**Review of the
Highland Wind Project
Visual Impact Assessment**

James F. Palmer

April 11, 2011

Figure 1. Profile graphs from the Arnold Trail viewpoint in West Carry Pond showing the line-of-sight to turbine 18W on the Bald Mountain (top) and 24E on Burnt Hill (bottom).

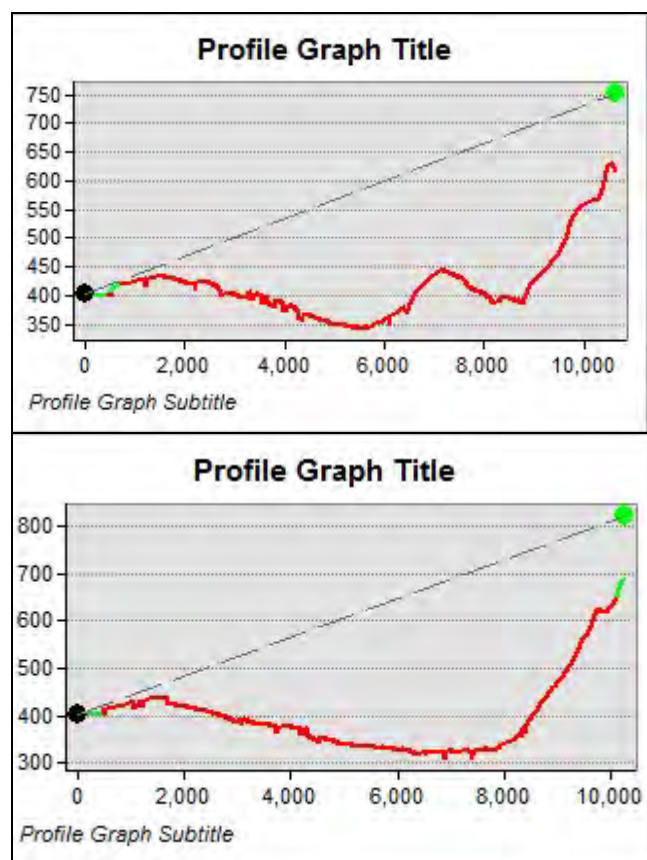
were placed too low in WindPRO. I do not have field measurement for the shoreline tree buffer's height, so it is not possible to create line-of-sight profiles to accurately investigate this issue. However, I can create profiles using the tree heights used by TJD&A in the VIA. Figure 1 shows the results. Most of the turbine marked 18W in the visualization will be visible, but its foundation will not. However, turbine 18W will be visible with its foundation area and the top of the hill. There appears to be a possibility that the turbines may be more visible than indicated in the Photosimulation.
